**Redevelopment at the Avondale
Drive Estate, Hayes:
Aviation Safeguarding Assessment
Addendum to Report
EAS/P1238/R1/Issue 1**

KLG192/R1/Rev 2

Report prepared on behalf of London Borough of Hillingdon

Figure 1: Maximum parameter plan assessed in November 2021**Figure 2: Revised Maximum parameter plan for S73 application**

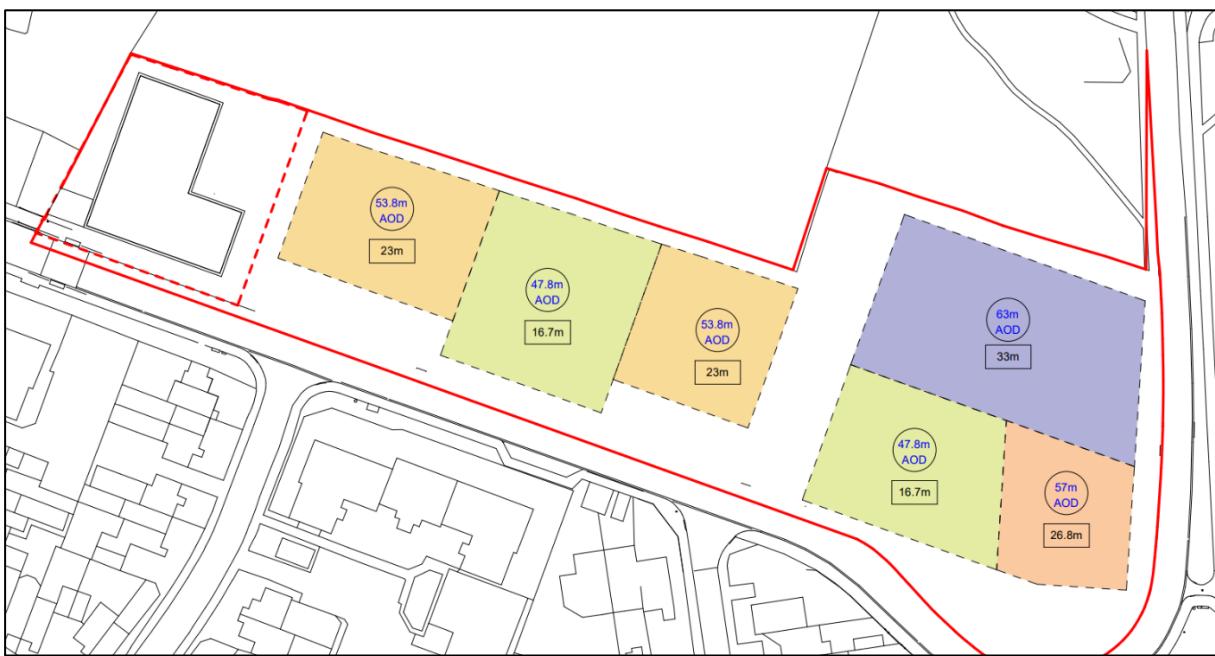
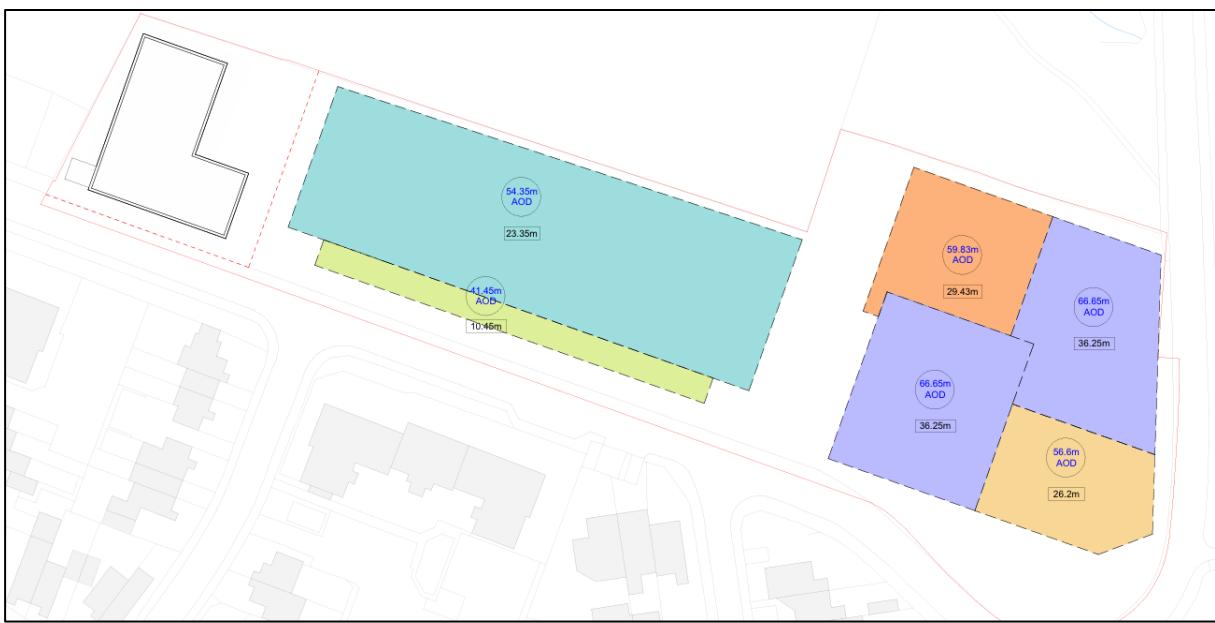
For comparison purposes, Figures 1 and 2 show the maximum heights parameter plans for the consented and proposed amended schemes, respectively. It is evident that whilst some of the heights have increased slightly and the massing arrangement has changed, from an aviation safety perspective, the changes do not appear to be significant.
